Z-27  
(2013)  
REVISED SITE  
PLAN

**PETITION NO:** Z-27

# Z-27

**ZONING COMMENTS:**

**REVISED**  
Z-27/2013

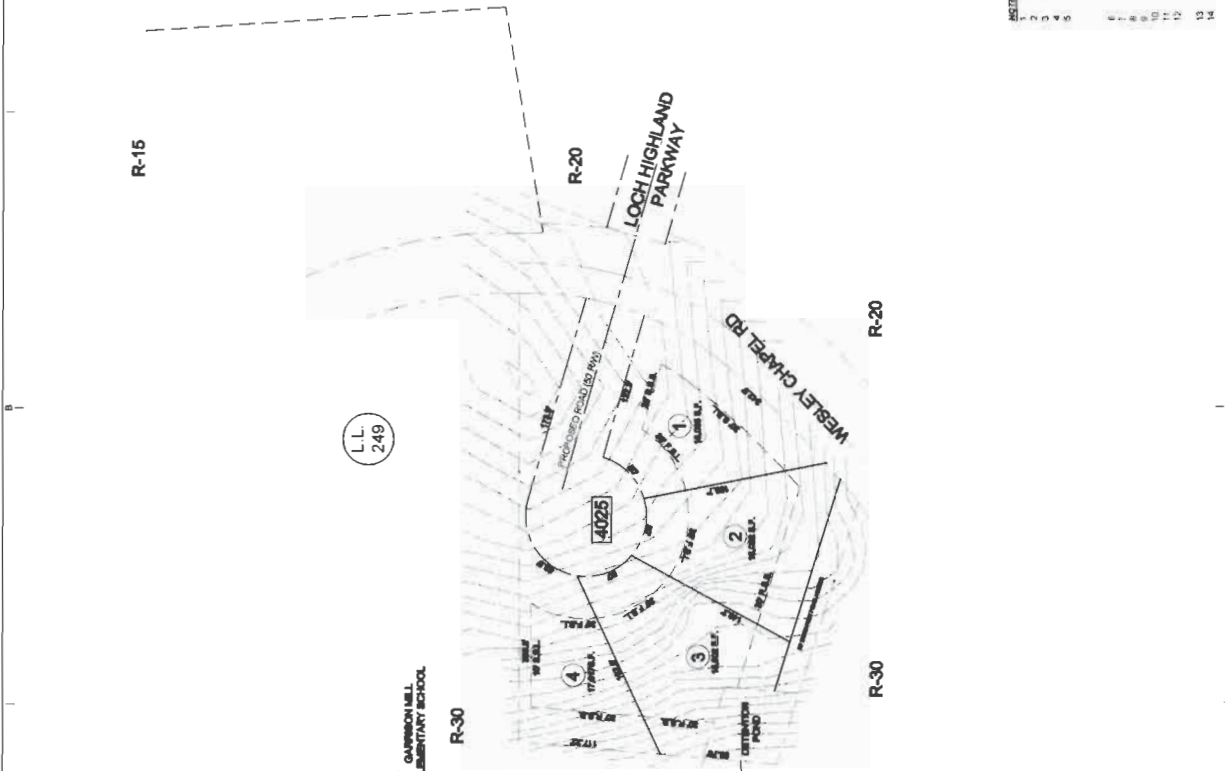
- Provide comprehensive hydrology/stormwater controls to include development of out parcels.
- Submit all proposed site improvements to Plan Review.
- Any **spring activity** uncovered must be addressed by a qualified geotechnical engineer (PE).
- Structural fill \_\_\_\_\_ must be placed under the direction of a qualified registered Georgia geotechnical engineer (PE).
- Existing facility.
- Project must comply with the Water Quality requirements of the CWA-NPDES-NPS Permit and County Water Quality Ordinance.
- Water Quality/Quantity contributions of the existing lake/pond on site must be continued as baseline conditions into proposed project.
- Calculate and provide % impervious of project site.
- Revisit design; reduce pavement area to reduce runoff and pollution.

- No Stormwater controls shown \_\_\_\_\_
- Copy of survey is not current – Additional comments may be forthcoming when current site conditions are exposed.
- No site improvements showing on exhibit.

1. This parcel is located to the west of Wesley Chapel Road and is bounded by the Robert Hicks Farm to the south and Garrison Elementary School to the north and west. Approximately a third of the site drains to the south along the right-of-way of Wesley Chapel Road. The remainder of the site drains to the southeast through the Robert Hicks Farm property. Stormwater conveyance through this parcel is limited. There is an existing 18-inch CMP culvert located at the property line that flows under an existing barn/shed. This pipe discharges into an existing farm pond with limited spillway capacity. Detailed hydraulic analysis will be required at Plan Review to verify no adverse impact to these offsite systems.

2. While the location of the detention pond is at the low point of the site, the proposed access from the right-of-way is along the southern boundary of the site and will require total clearing for maintenance access. This will eliminate any buffer for the adjacent property owner.

3. A pre- and post-development sediment survey will be required for the downstream farm pond.
